Value Engineering Study

I-65 WIDENING

**ITEM NUMBER 4-15.00, 4-16.00, 4-17.00, 4-18.00, 4-19.00
VE STUDY NUMBER 201302**

Final Report

VALUE ENGINEERING RECOMMENDATION # VE-2

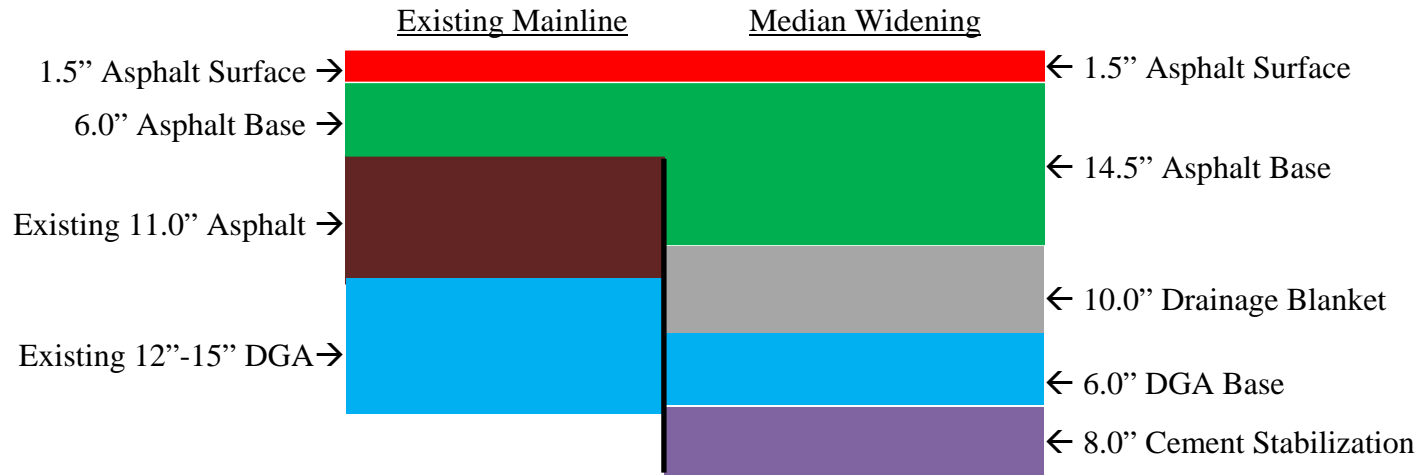
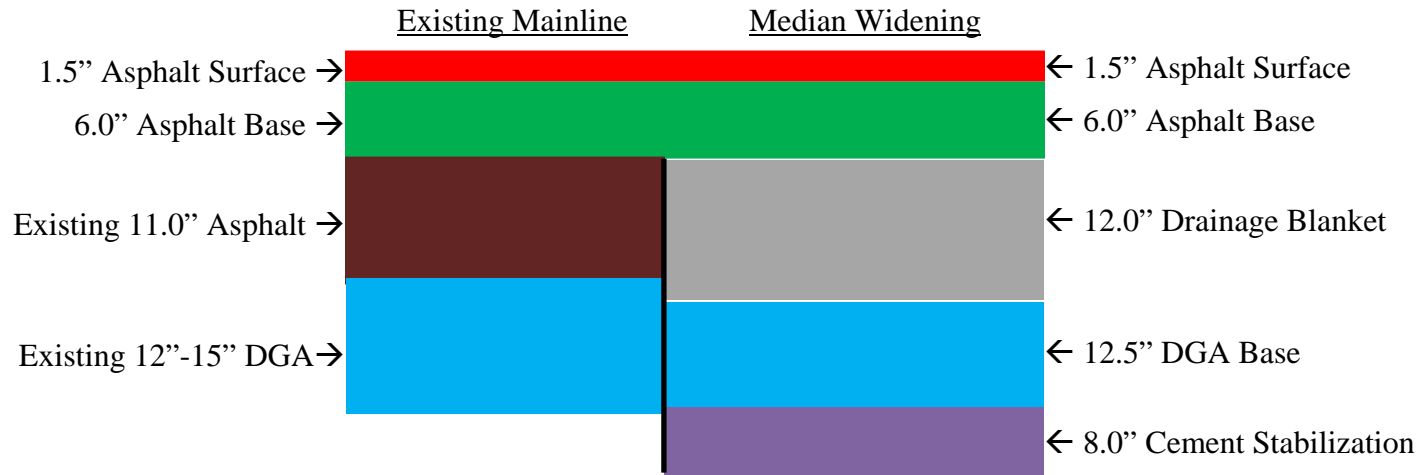
Assuming ~55,000 ADT (2035), use thinner asphalt pavement section with a thicker base section in lieu of current design.

The VE Team recommends that the pavement buildup be evaluated for the current traffic projections of 55,000 ADT and approximately 63×10^6 ESALs (see Design Comment VE-1) in lieu of the original 75,000 ADT. Required structural number would likely be between 7.83 (CBR 4) and 8.13 (CBR 3) with these projections according to preliminary calculations by Paul Looney of KYTC. Based on this, the VE Team recommends that the structural number of the widened pavement be reduced by changing the thicknesses of the layers as follows: 7.5 in. of asphalt, 12 in. Asphalt Drainage Blanket and 12.5 in. DGA. This would revise the structural number of this section to 8.2 while maintaining the same overall depth. The estimated asphalt overlay on the existing pavement may remain as estimated since the structural number of 7.8 is approximately equal to the required SN of 7.85 (for CBR 4) but may need to be increased if the CBR is 3.

The widened pavement is overdesigned in comparison to the existing pavement with overlay. The original pavement buildup contains more asphalt base than aggregate base which provides unnecessary strength. Asphalt base costs twice as much as aggregate base. If the sole intent of the added thickness is to match the existing pavement thickness thereby facilitating drainage of the existing subbase, then the added thickness could be accomplished in less expensive layers without reducing the strength of the widened pavement below that provided by the existing (with overlay).

VALUE ENGINEERING RECOMMENDATION # VE-3

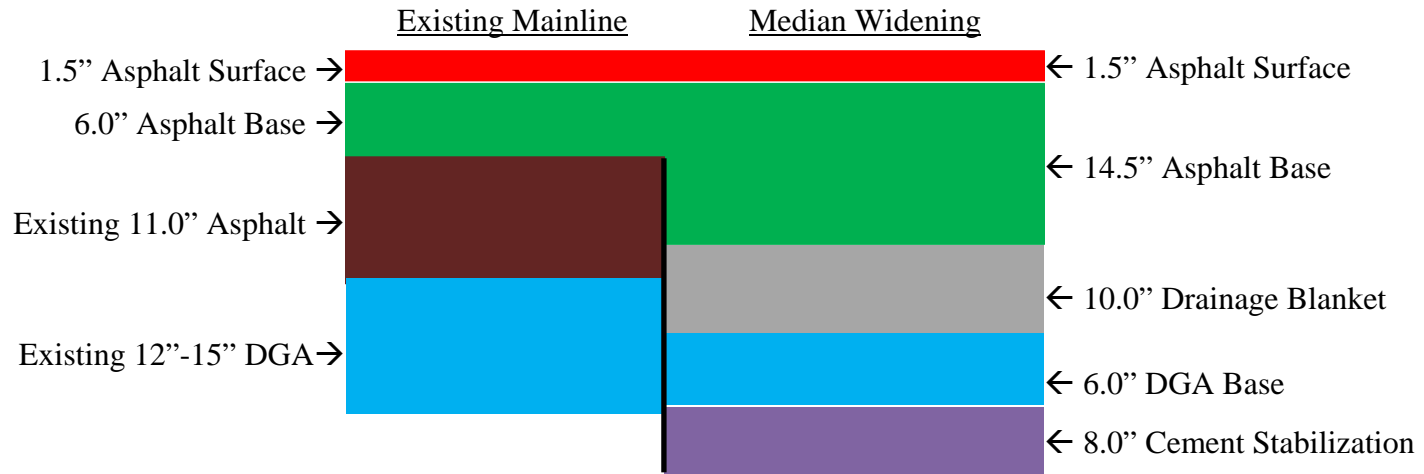
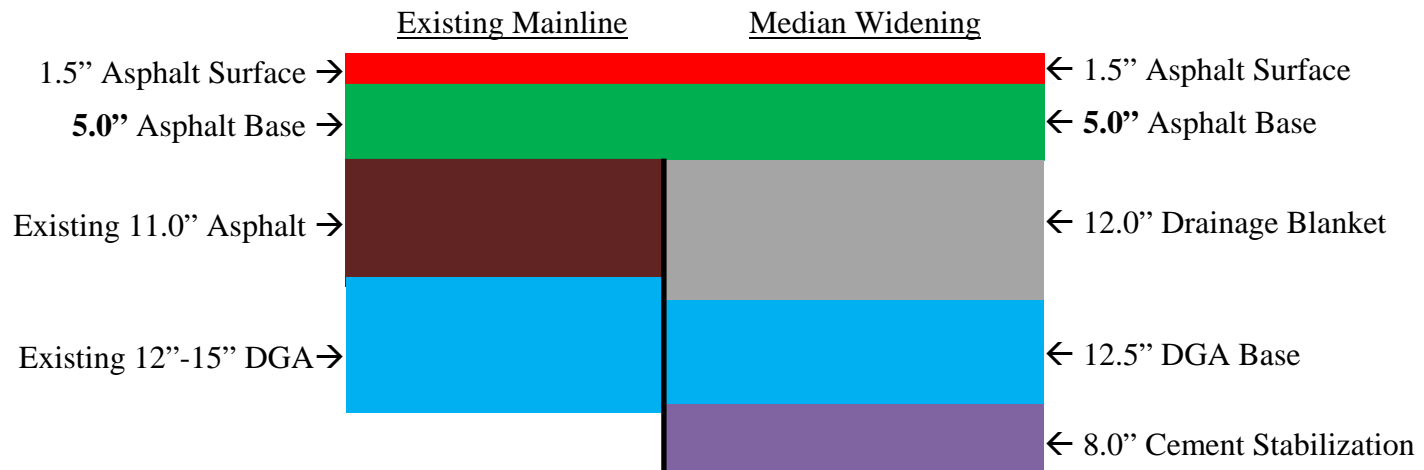
Construct vertical clearances for maximum asphalt overlay, but only install the amount of asphalt needed for next 10 years and add additional overlay in the future if necessary.

Traffic projections in this corridor have been lower than originally expected. The pavement can be strengthened easily in the future by constructing additional depth when the roadway is resurfaced. The estimated structural number required for the 10 year traffic would be approximately 7.4 according to a preliminary calculation provided to the VE Team by Paul Looney of KYTC. The 1 in. reduction in asphalt base thickness would likely provide the required SN to accommodate the anticipated 10 year traffic. A reevaluation of traffic can be performed after 10 years to verify the need for additional strength.

VALUE ENGINEERING RECOMMENDATION # VE-4

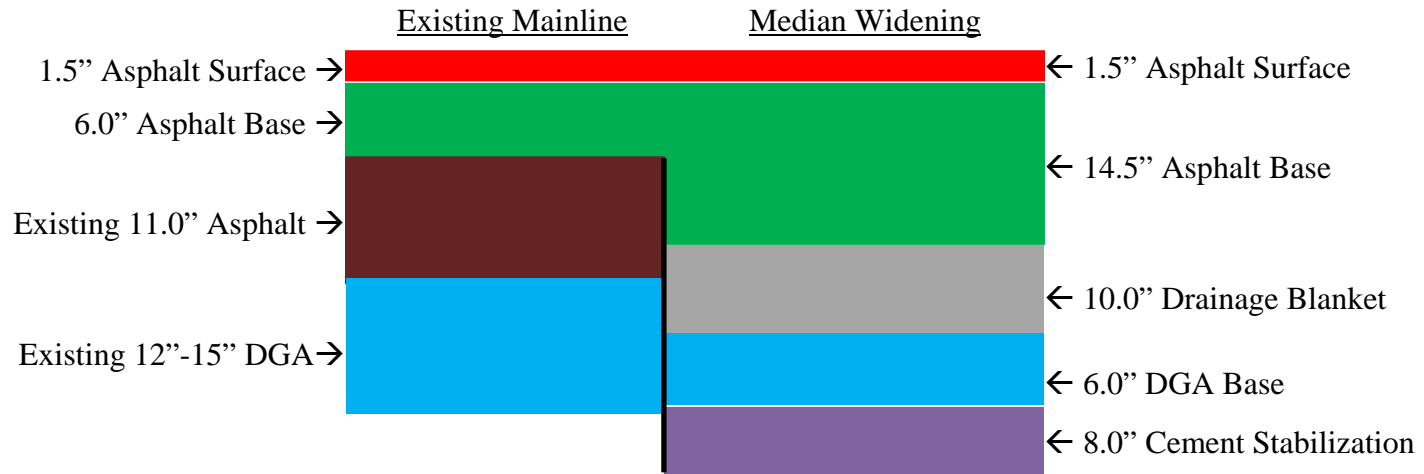
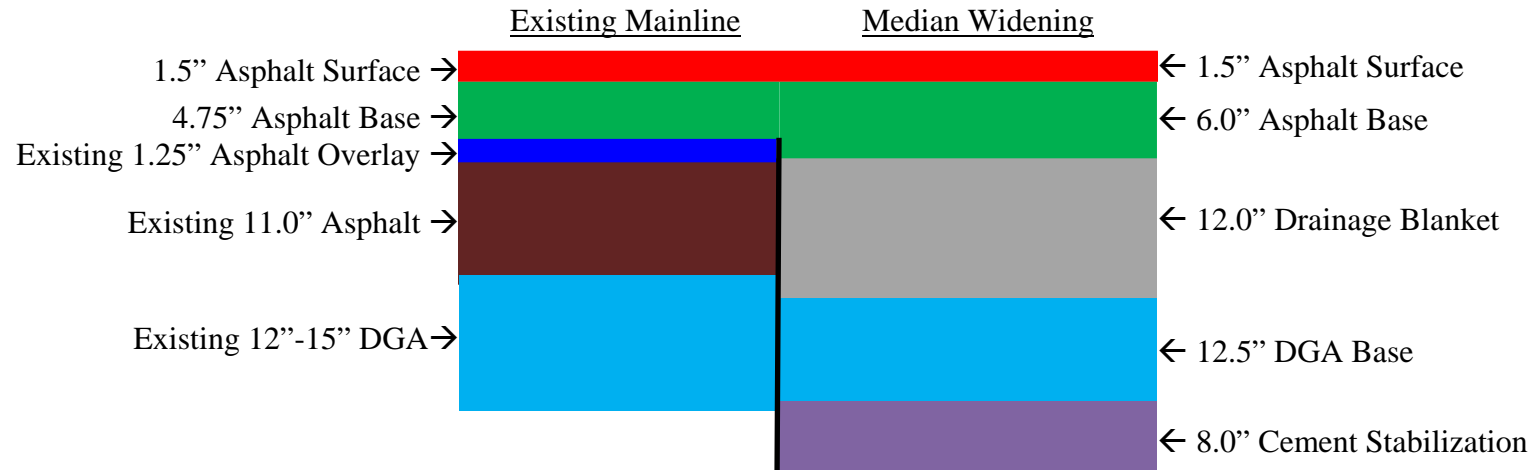
The recent overlay thickness provides is still in good condition and can contribute to the required pavement strength. The cost of the asphalt base can be reduced by accounting for the strength already in this section. Note that the thickness of the 2011 overlay and whether or not the existing surface was milled needs to be verified. If existing surface was milled, then no change in the overlay thickness is recommended.

VALUE ENGINEERING RECOMMENDATION # VE-5

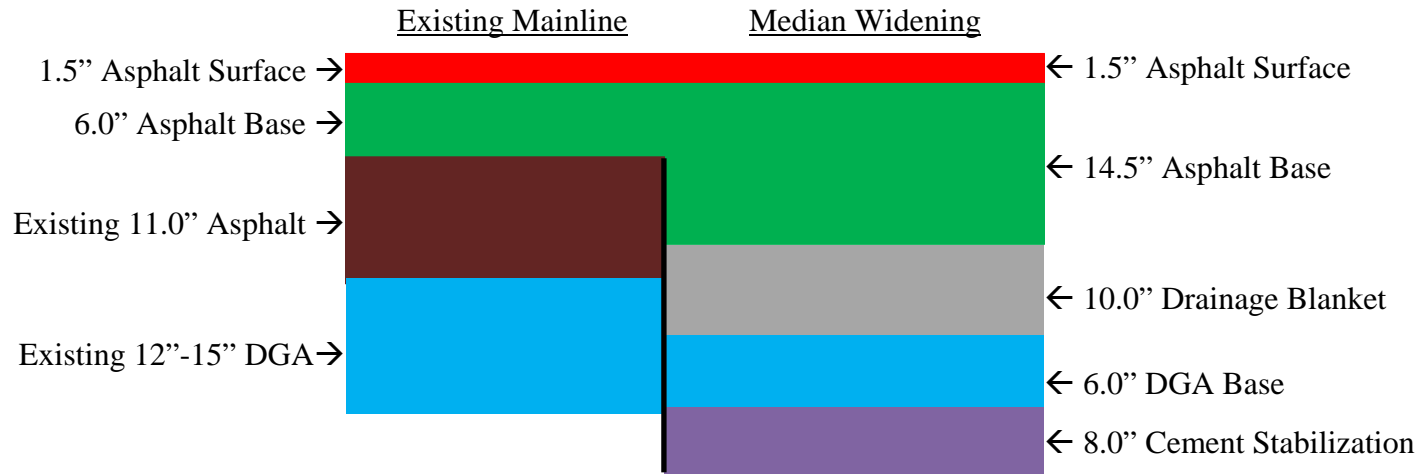
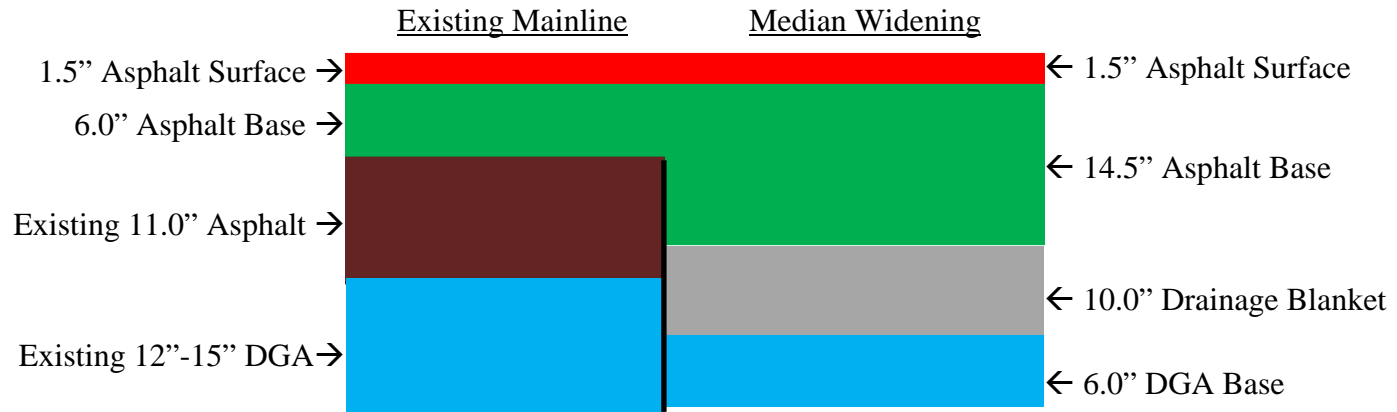
The original design specifies cement soil stabilization for the widened pavement. According to KYTC staff, the stabilization specified for this project is based on experiences with other widening projects on I-65. On those projects, the cement stabilization was not necessarily needed to improve the strength of the subgrade. Rather it was used to provide a stable working platform during construction, especially in cases where the soil subgrade may become saturated during winter or spring. This softens the subgrade, makes the subgrade susceptible to rutting and may affect the long term strength of the subgrade.

VALUE ENGINEERING RECOMMENDATION # VE-6

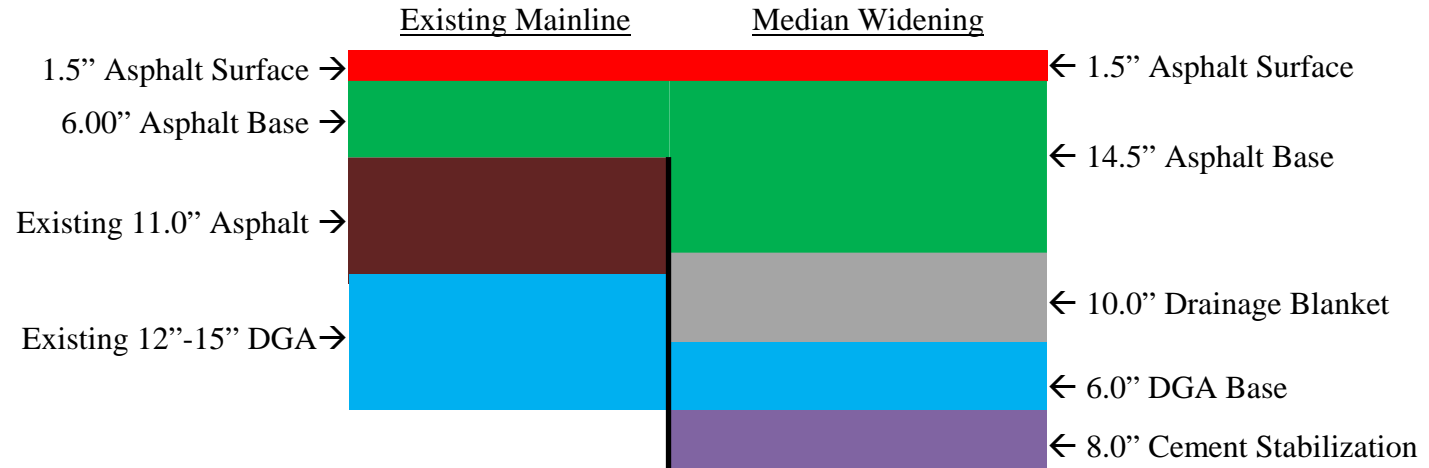
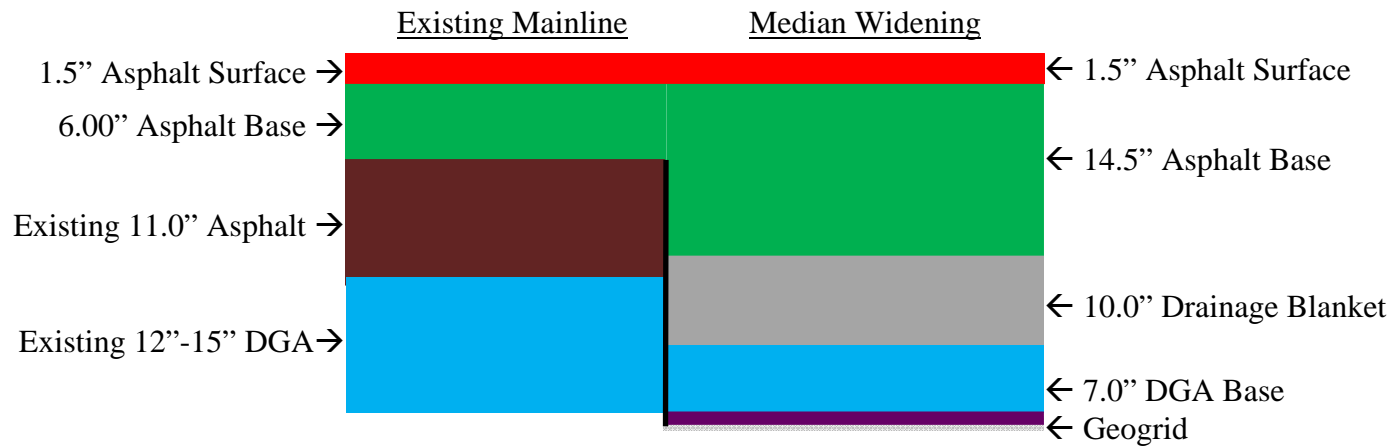
The original design specifies using cement stabilization for the widened section of the roadway. According to KYTC staff, this stabilization is to provide a working platform during construction in case the subgrade soils become saturated.

The cost analysis includes an additional 1 in. thickness of DGA to the original design DGA thickness of 6 in. to provide a minimum depth of 7 in. DGA according to the KYTC Pavement Design Manual. If the alternative pavement design in Recommendation 2 is utilized (DGA thickness = 12.5 in.), the cost of this recommendation could be reduced by an additional \$1.2 million because no additional DGA thickness would be required to meet the 7 in. minimum thickness.

VALUE ENGINEERING RECOMMENDATION # VE-7

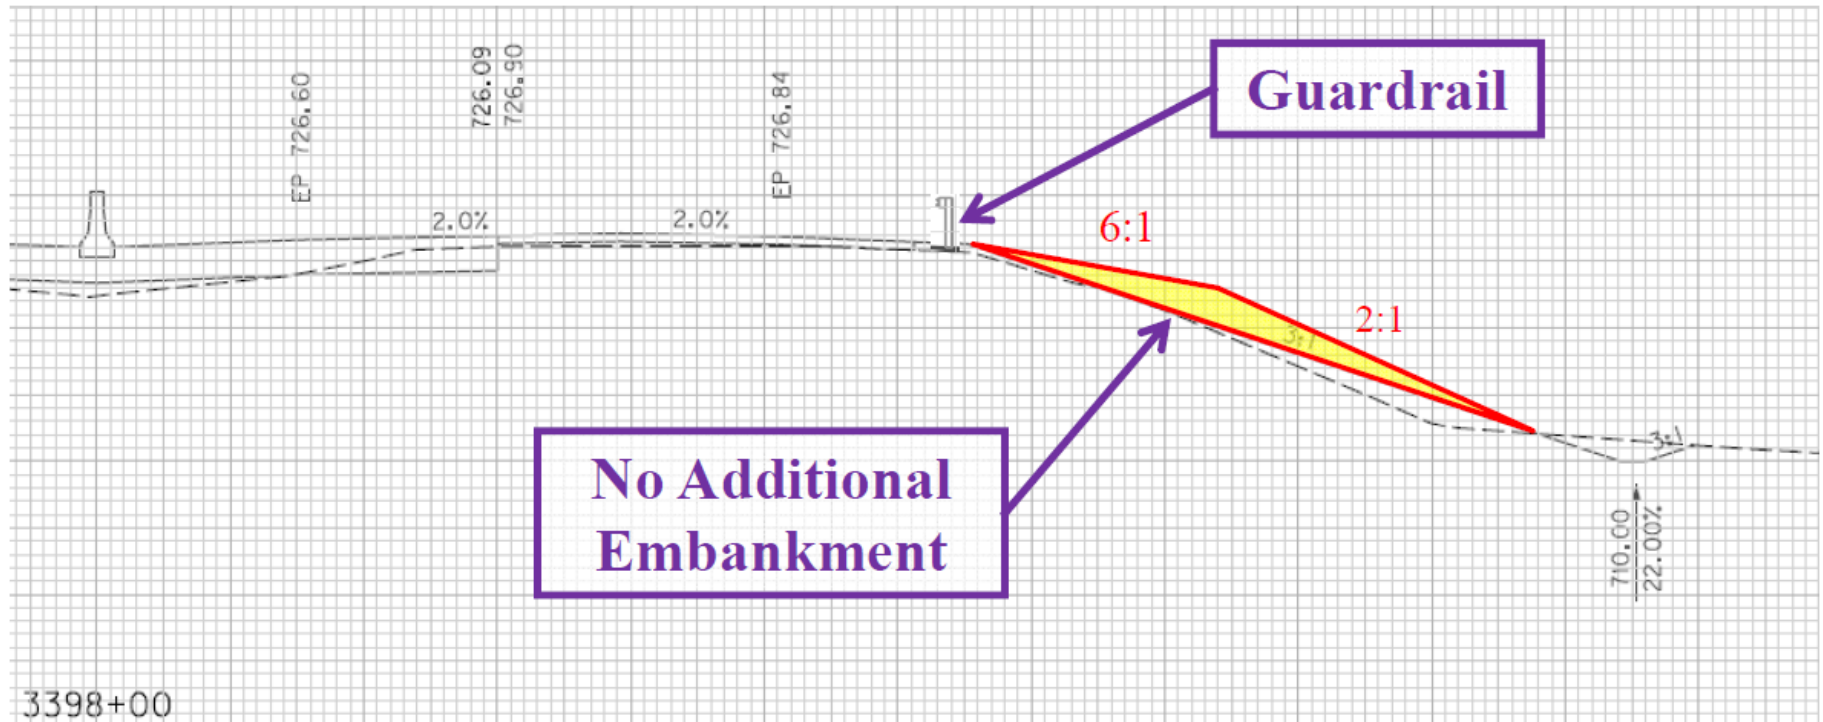
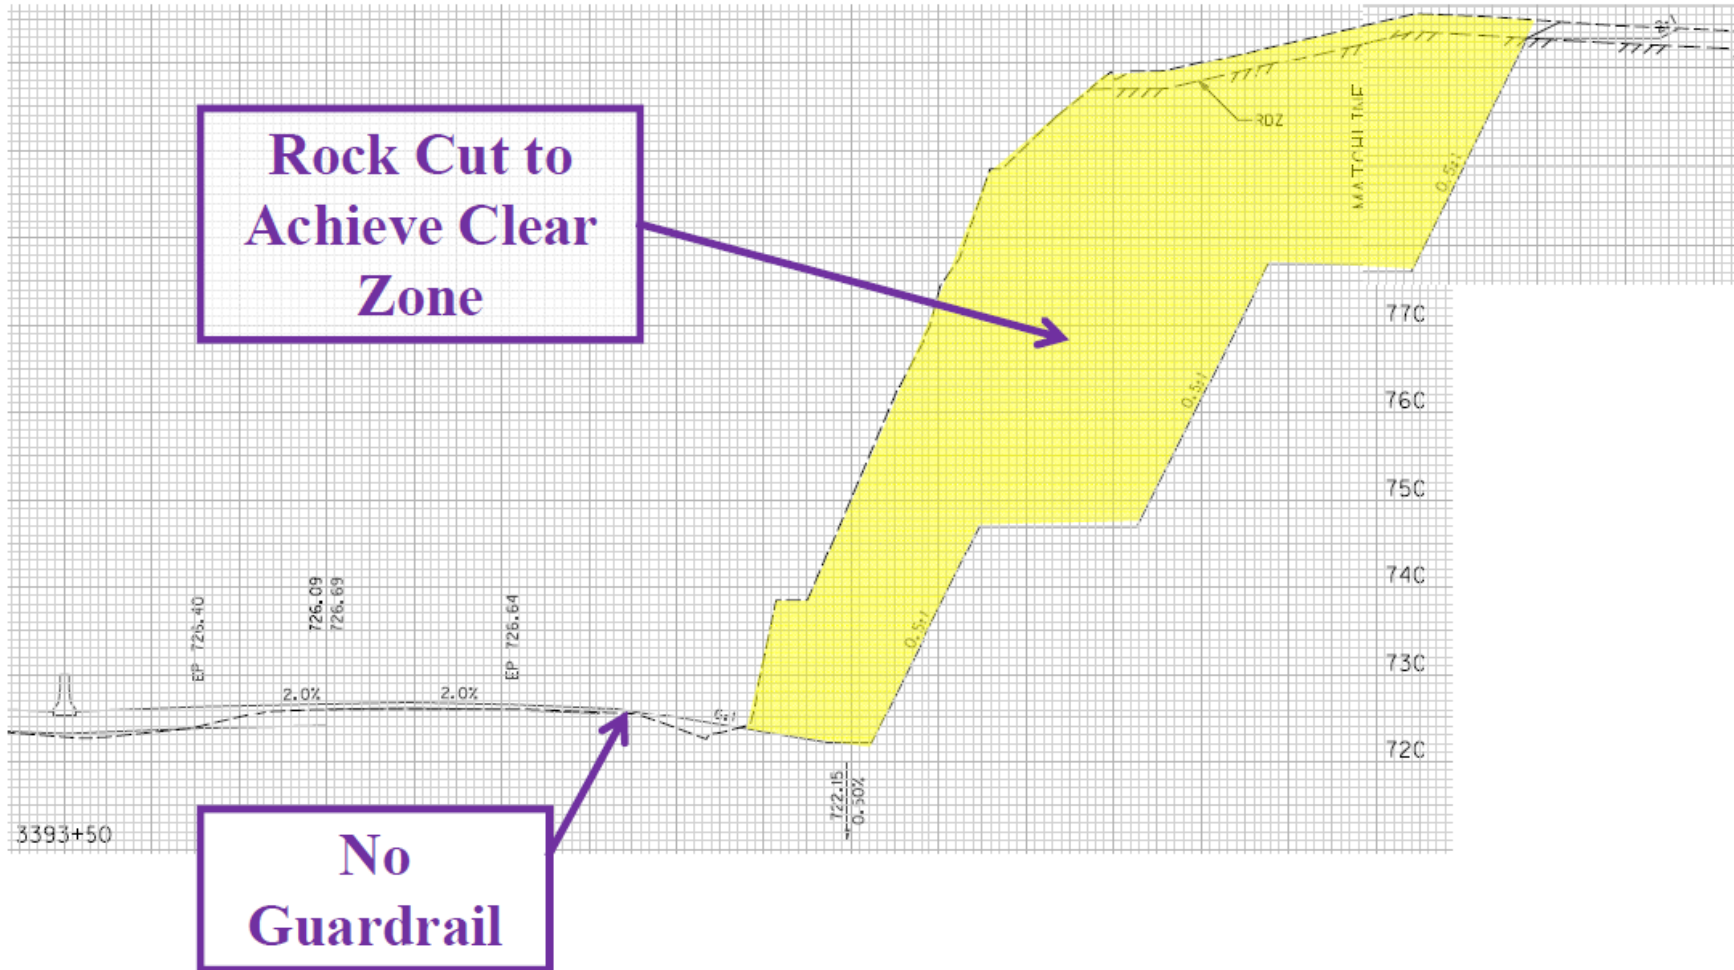
The VE Team recognizes the importance of providing a consistent clear zone and agrees that clear zone should be provided in the vast majority of the project. However, due to the height of cut in this 600 ft segment, this rock removal costs approximately \$452,000, which averages approximately \$750 per ft. If it is acceptable to provide guardrail at a 12-ft offset in high fill segments, then the VE Team believes that it might be acceptable to provide guardrail in deep cut segments. It is acknowledged that the savings would be reduced by the cost of guardrail at \$15 per ft.
